## PLANNING APPLICATIONS COMMITTEE – ADDENDUM PUBLISHED 29 NOVEMBER

Date: **Tuesday 3 December 2019**

**ITEM 2**  
**Lansdowne Wood Close**  
**18/03492/FUL**

**PLANNING APPLICATIONS COMMITTEE 3RD DECEMBER 2019**  
**FIRST ADDENDUM: AMENDMENTS AND ADDITIONAL INFORMATION ON AGENDA ITEMS**

Figure 8 - lower ground floor as now proposed

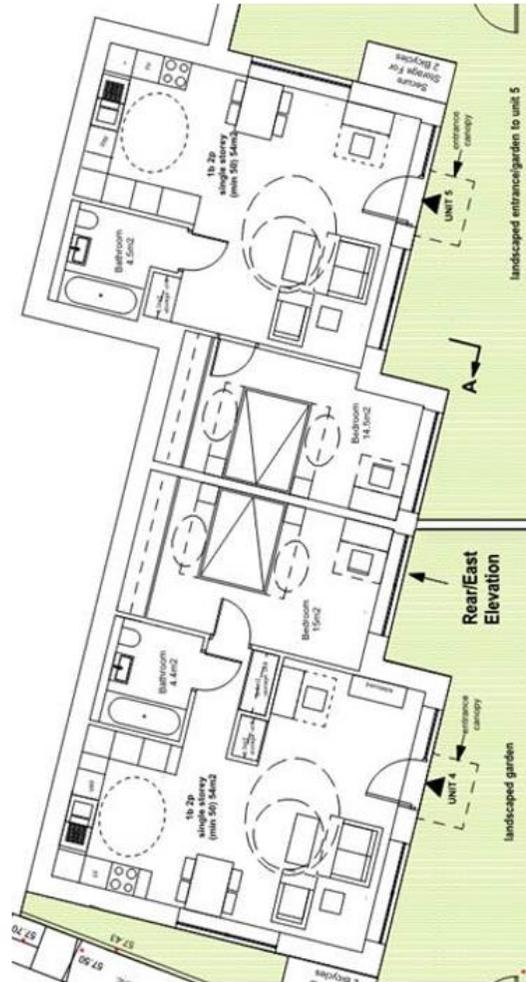
Insert missing image (figure 8)
